UNITED STATES PATENT AND TRADEMARK OFFICE

APPLICATION NO.	FILING DATE	FIRST NAMED INVENTOR	ATTORNEY DOCKET NO.	CONFIRMATION NO.
10/785,598	02/24/2004	Junwon Lee	87163AEK	3196

Office Action Summary	Application No. 10/785,598	Applicant(s) LEE ET AL.	
	Examiner Jacob Y. Choi	Art Unit 2875

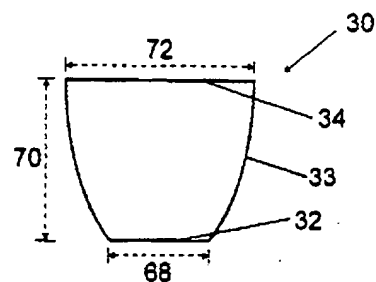
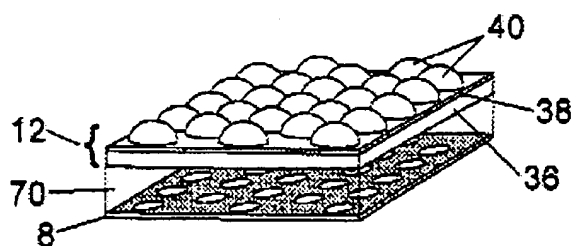
Regarding claim **1**, Zimmerman et al. discloses an array of tapered structures (e.g., 33), each the tapered structure (e.g., 33) having a light input aperture (e.g., 32) and a larger light output aperture (e.g., 34), wherein the inner surface of each the tapered structure (e.g., 33) is adapted to reflect off-axis light incident and at the input aperture (32) to the output aperture (34) in which the array of tapered structures (e.g., 33) comprises an array of concentrators (e.g., 10) extending between an input aperture (e.g., 32) on an input surface and an output aperture (e.g., 34) on an output surface, each the concentrator having a *generally* parabolic shape (e.g., column 8, lines 20-30;

"... Sidewalls 33 connect input surface 32 to output surface 34. Sidewall 33 can be straight, but preferably, sidewalls curve outwardly as shown in Figure 4 ... etc.") taken from the light input aperture to the light output aperture wherein, in a cross-section parallel to the output aperture, the tapered structure is substantially circular (e.g., Figure 3C).

Things clearly shown in reference in reference patent drawing qualify as prior art features, even though unexplained by the specification (e.g., generally parabolic shaped tapered structure). *In re Mraz*, 173 USPQ 25 (CCPA 1972).
